**WHITE LAKE TOWNSHIP
INTER-OFFICE MEMORANDUM**

**SUBJECT: Lakepointe
Final Site Plan Re-approval
Revised Planned Development Agreement Approval**
Located on the northeast corner of Union Lake Road and Carpathian, consisting of approximately 13.32 acres. The property is currently zoned PD (Planned Development). Identified as parcel number 12-36-177-008.

RE: Lake Pointe – Final Site Plan and Final Engineering Plan –7th Review

**RE: Lake Pointe – Final Site Plan Backcheck #4
Parcel Number 12-36-177-003**

5B entrance sign elevation
 SCALE 1"=4'-0"

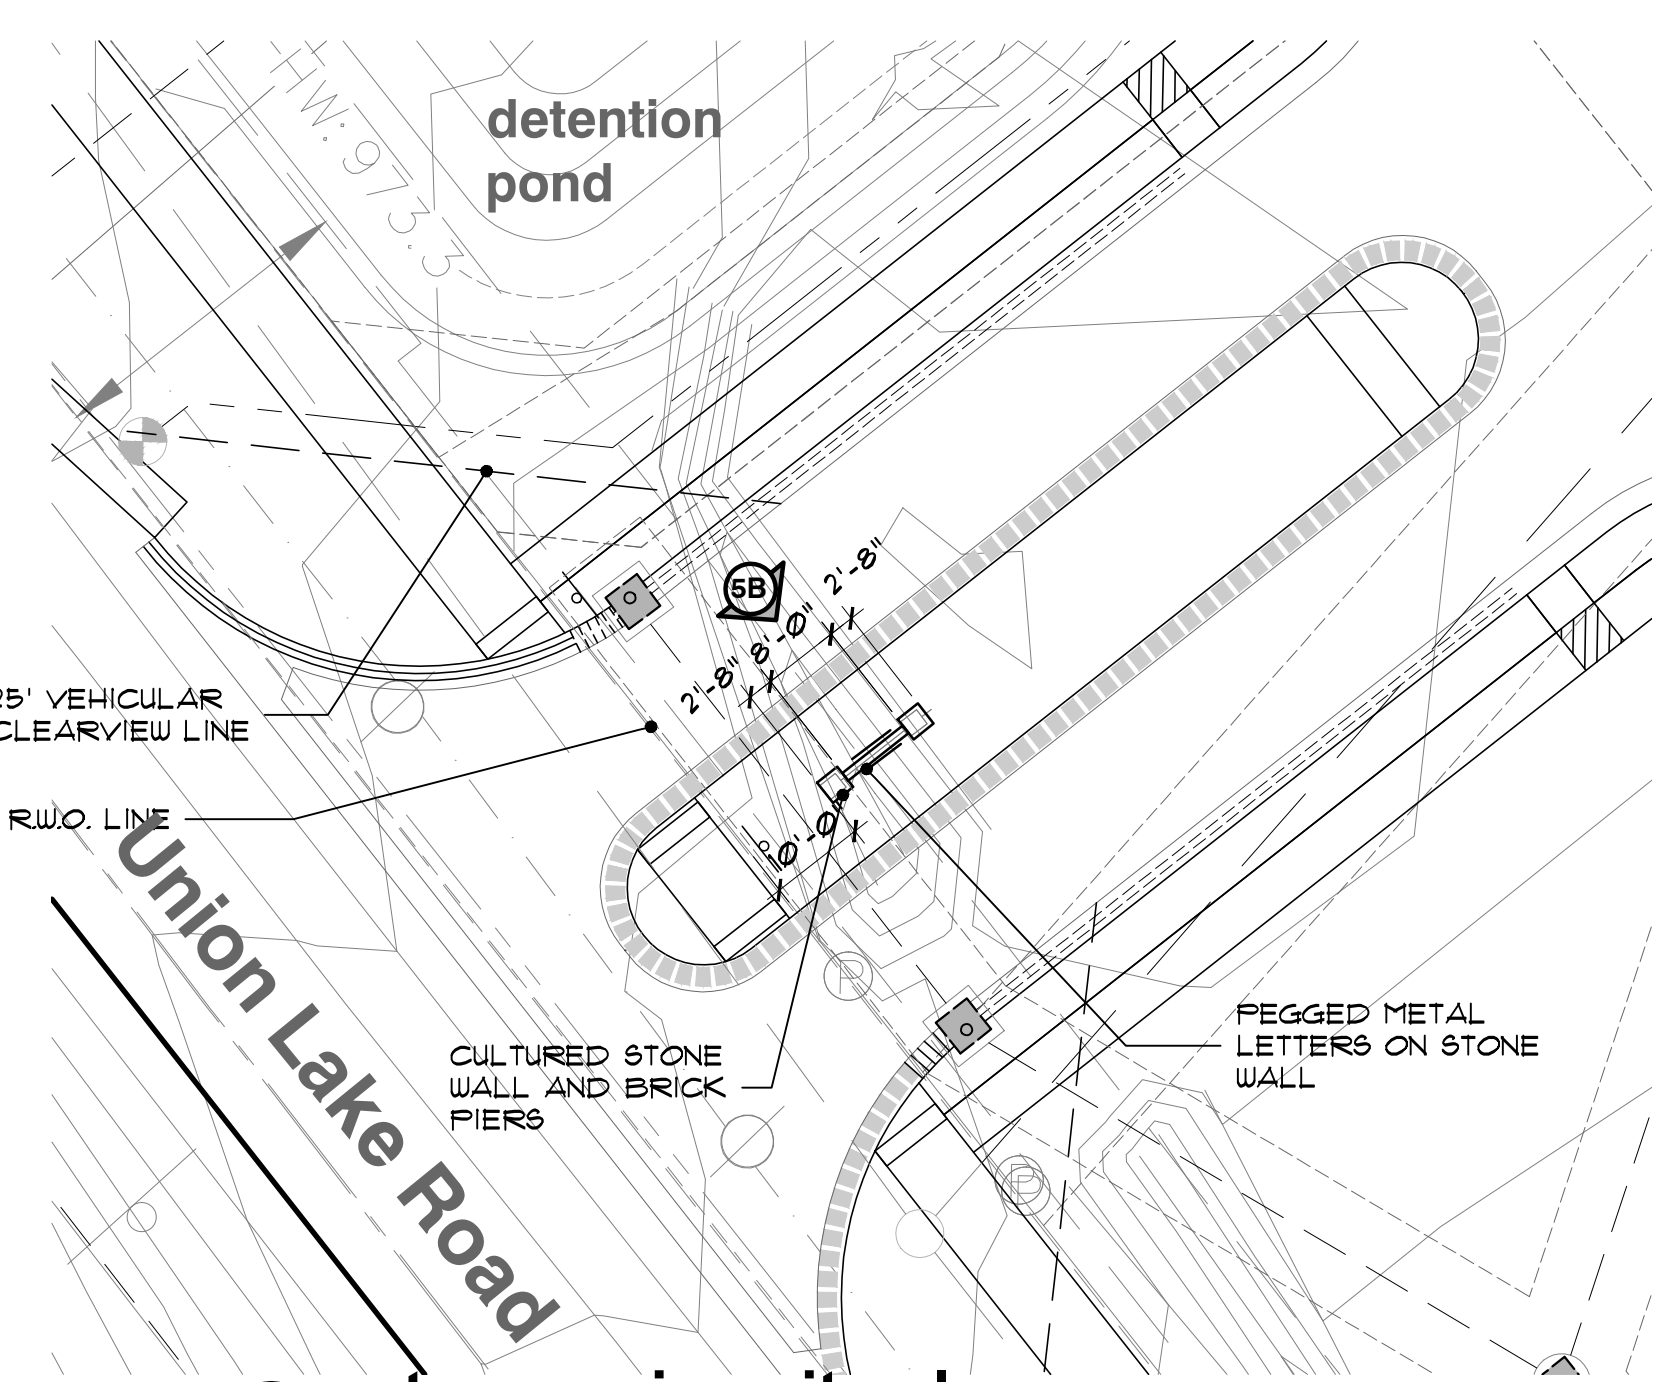
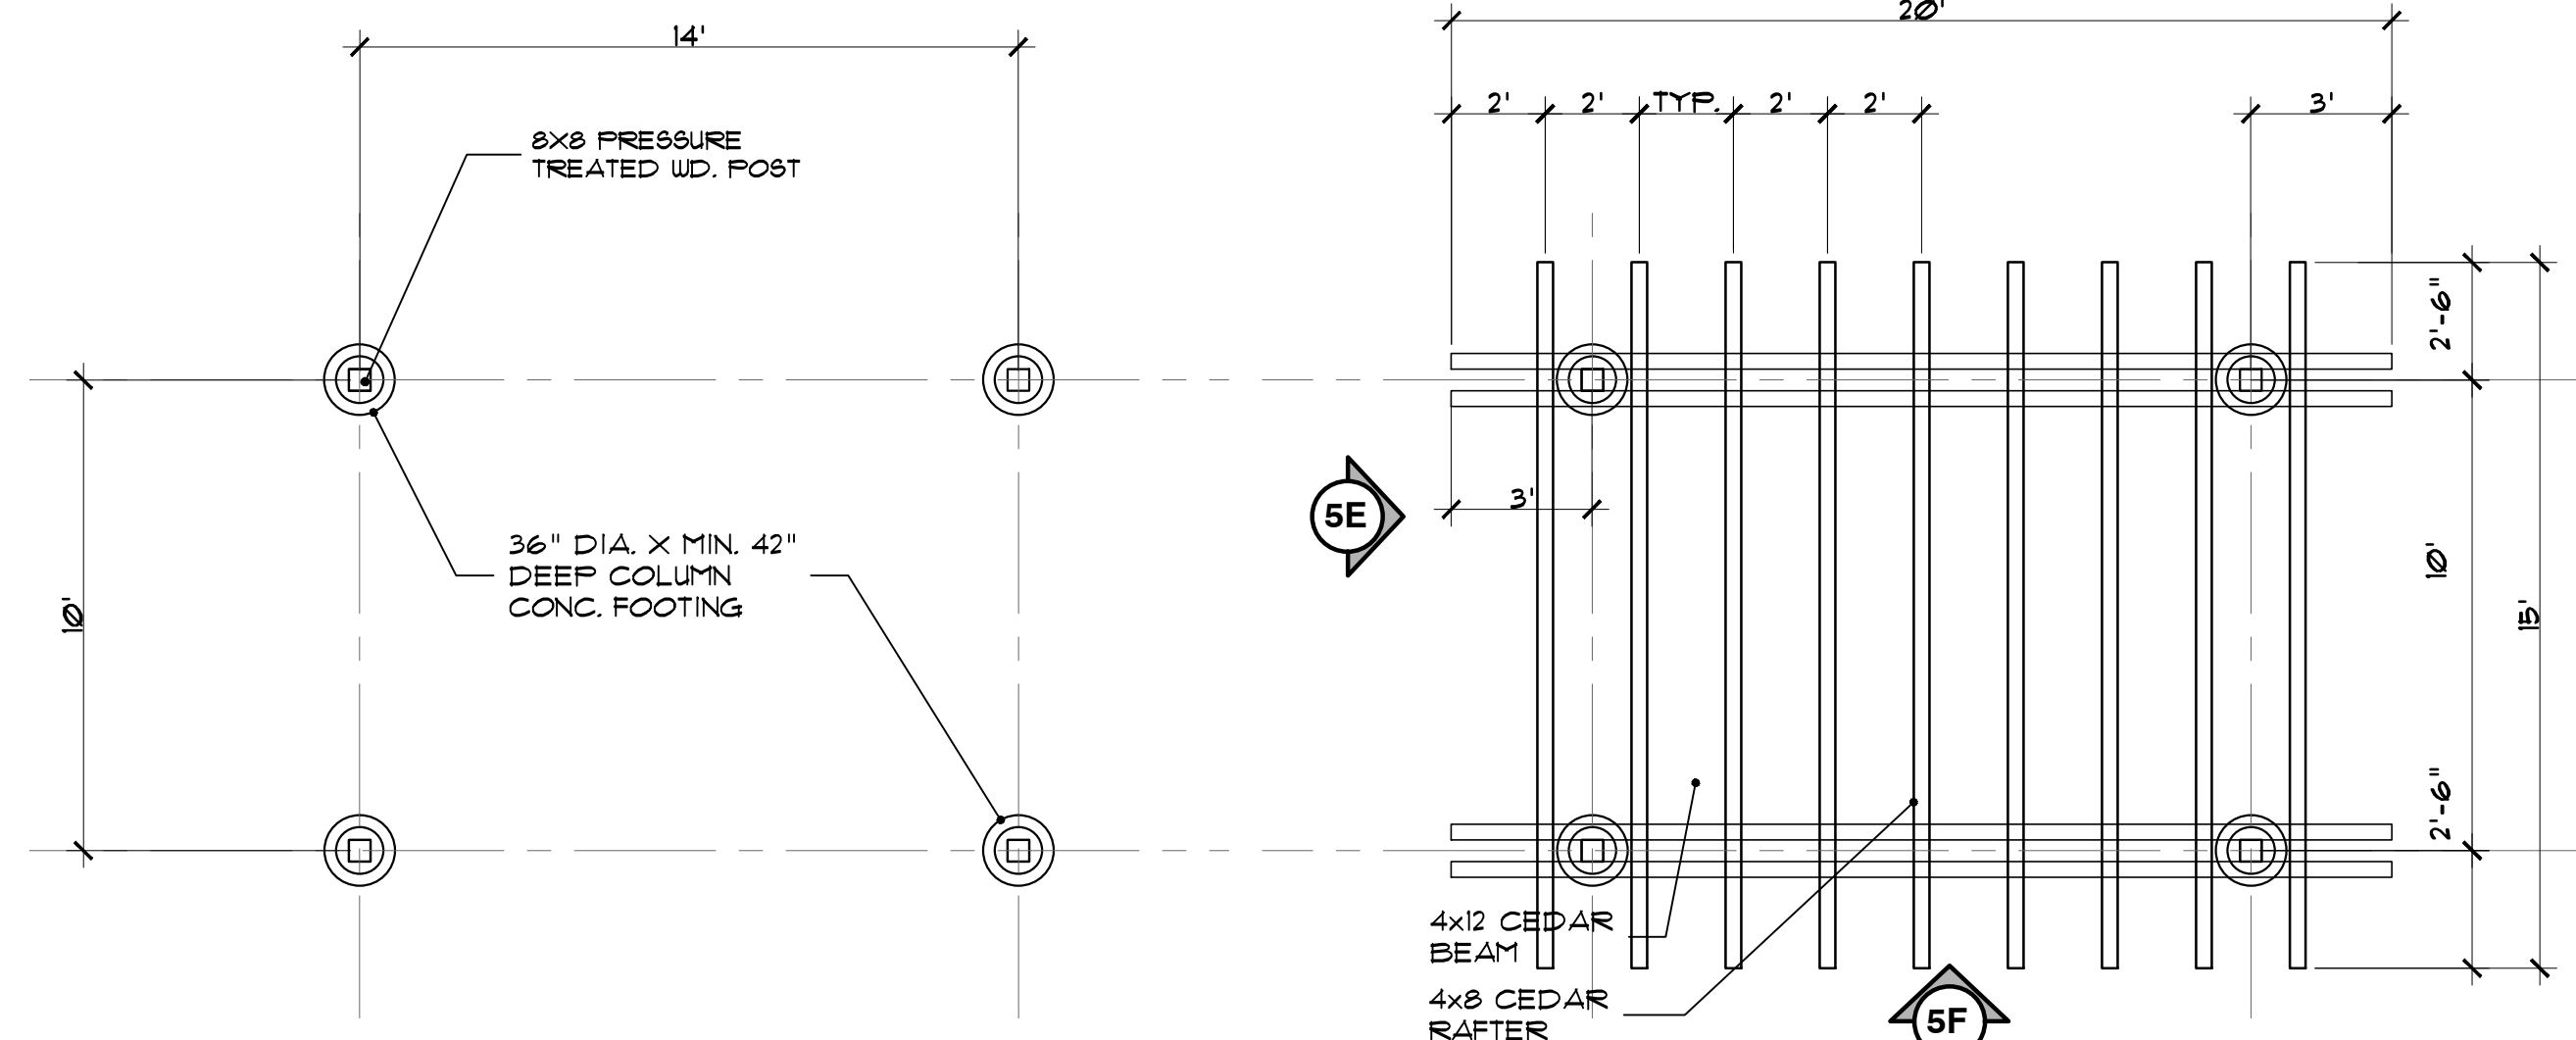
- **The lighting fixture specification sheet (cut sheet) shall be submitted for the proposed entrance sign panel “uplighting.” The method of sign illumination is subject to review and approval by the Planning Division. Note uplighting is prohibited in the Township and the sign panel uplighting detail on Sheet LS-4 shall be removed.** (Comment addressed. The sign panel uplighting detail on Sheet LS-5 have been removed).

SHEET NUMBER
 A201

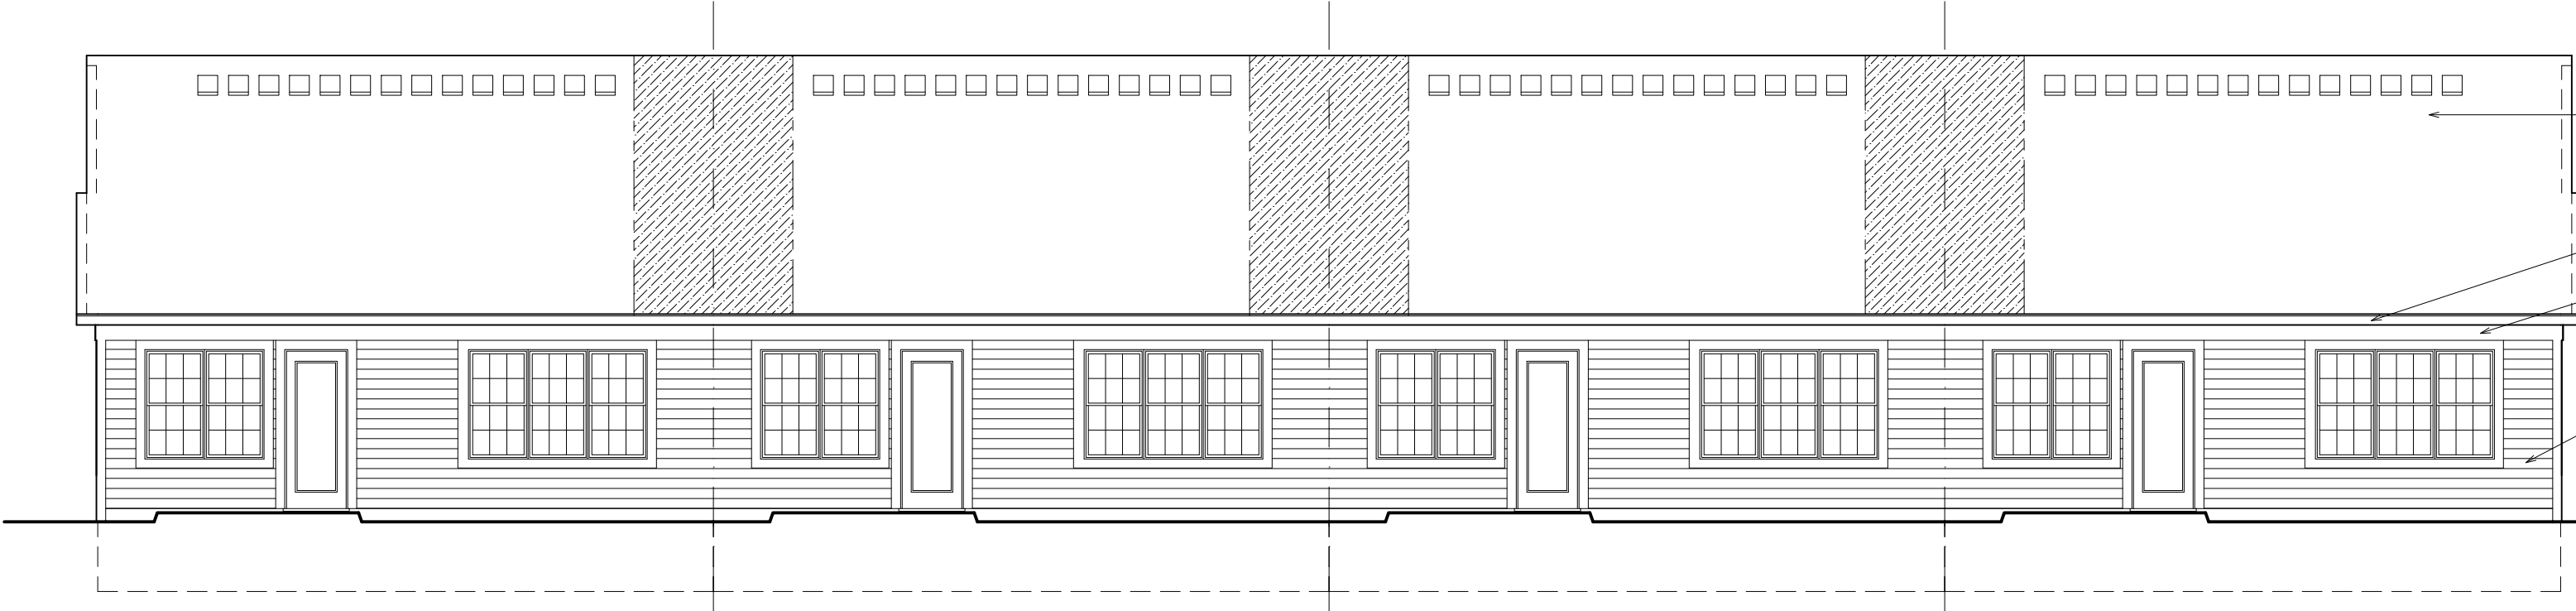
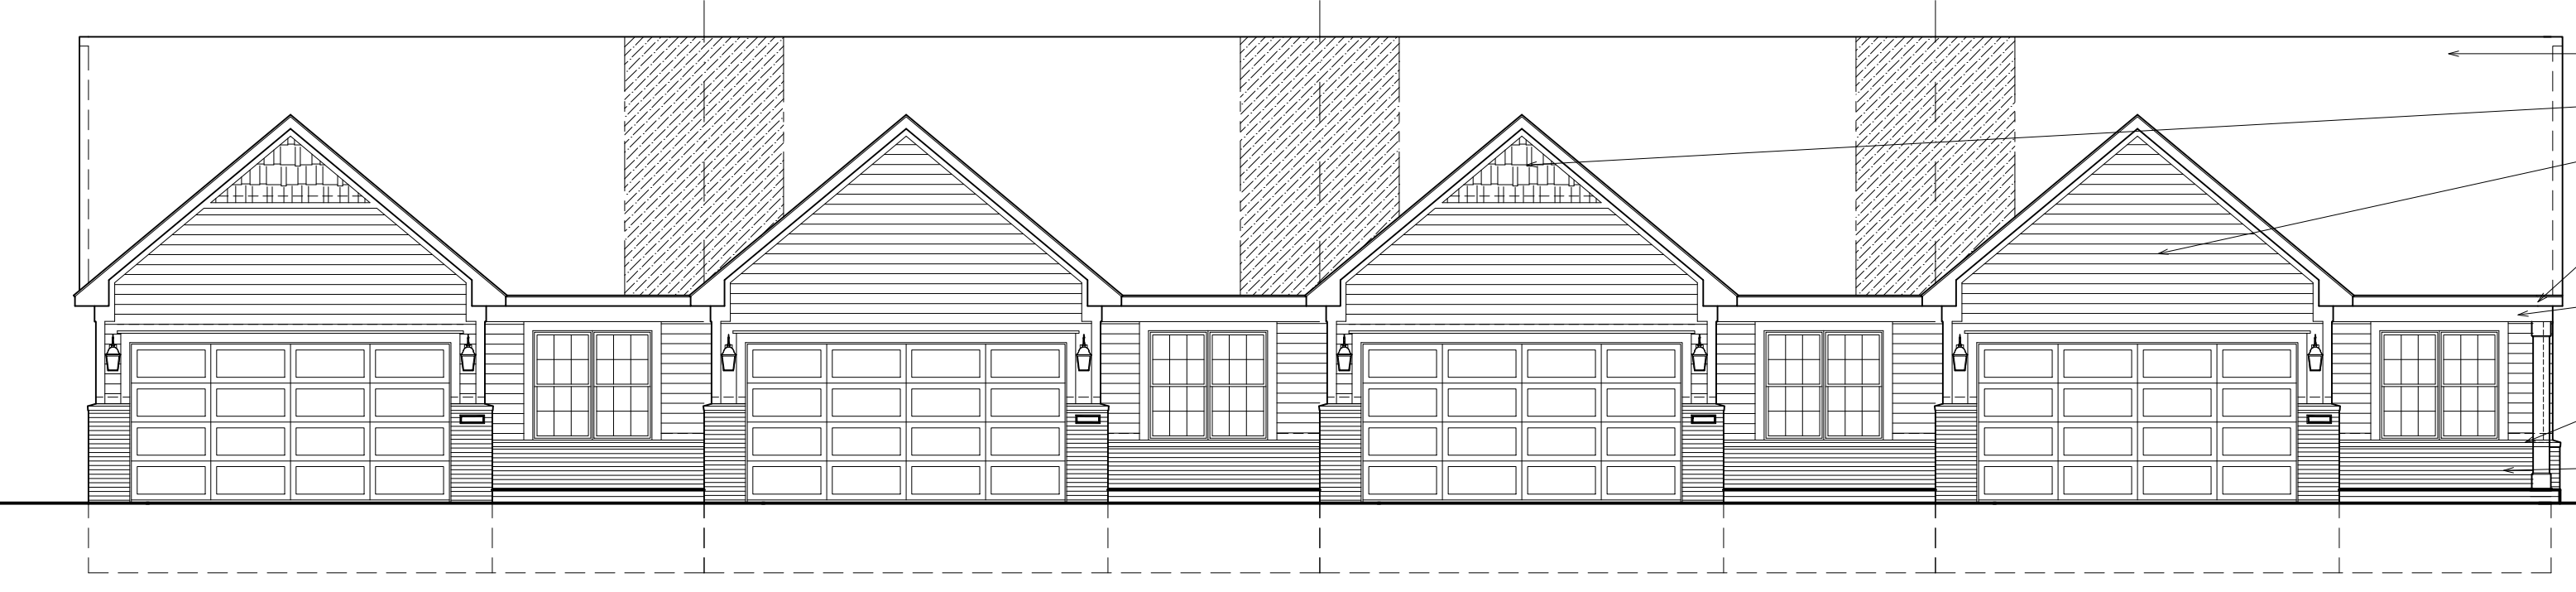
- As stated in previous correspondence (dated February 22, 2021), **the building materials shall be labeled on the building elevations, Sheets A201 and A203.** (Comment outstanding). (Comment remains outstanding). (Comment addressed. Material notations have been added to the elevations).
